Access Compliance Report

Public Rights-of-Way

(Curb Ramps)

Intersection ID: 11452	Main Street: E_16TH_ST	Cross Street: PARKWOOD_AV	Location: W
ADA ID: C275BB33E91D	Ramp Type: Perp	Initial Pass/Fail: Fail	Overall Compliance: No
Severity Score: 22.5			
Codes/Mitigation Info/Possible Solution		Field Measurements/Component Compliance

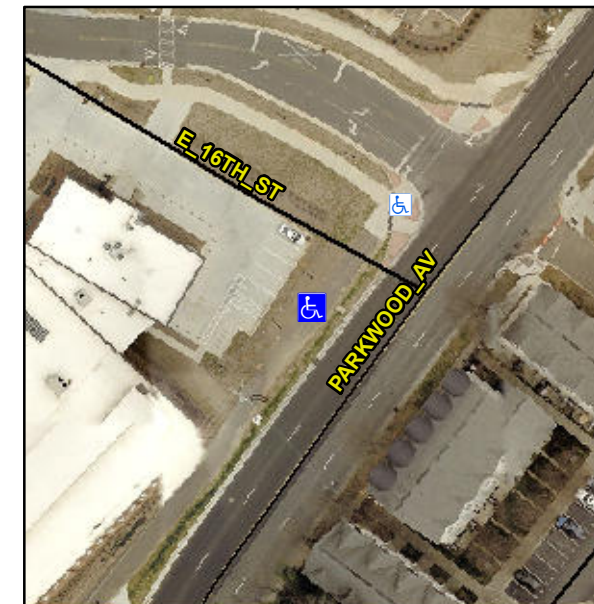
Not Found, R304.5.1, R304.2.2, R304.5.3

Compliance	Description	Data	Compliance	Description	Data
N/A	Ramp Length (in)	59.0	No	Ramp Slope (%)	9.1
No	Ramp Width (in)	43.0	No	Ramp XSlope (%)	3.1
N/A	Flare Type LT	N/A	N/A	Flare Type RT	N/A
N/A	Flare Slope LT (%)	N/A	N/A	Flare Slope RT (%)	N/A
N/A	Flare Traversable LT?	N/A	N/A	Flare Traversable RT?	N/A
N/A	Landing Length (in)	N/A	N/A	DWS Provided?	N/A
N/A	Landing Width (in)	N/A	N/A	DWS Contrast?	N/A
N/A	Landing Slope (%)	N/A	N/A	DWS Length (in)	N/A
N/A	Landing X Slope (%)	N/A	N/A	DWS Full Width?	N/A
N/A	Landing Curb? (Y/N)	N/A	N/A	DWS Offset (in)	N/A
N/A	Shared Landing?	N/A			
N/A	Gutter Ponding?	N/A	N/A	Gutter Slope (%)	N/A
N/A	Gutter Lip Ht (in)	1.0	N/A	Gutter X Slope (%)	N/A
N/A	Painted X Walk1?	No	N/A	Painted X Walk2?	N/A
	X Walk 1 Direction	To NE		X Walk 2 Direction	N/A
N/A	X Walk 1 Width (in)	N/A	N/A	X Walk 2 Width (in)	N/A
	X Walk 1 Slope (%)	1.4		X Walk 2 Slope (%)	N/A
	X Walk 1 X Slope (%)	1.1		X Walk 2 X Slope (%)	N/A

Remove & Replace Entire Ramp.
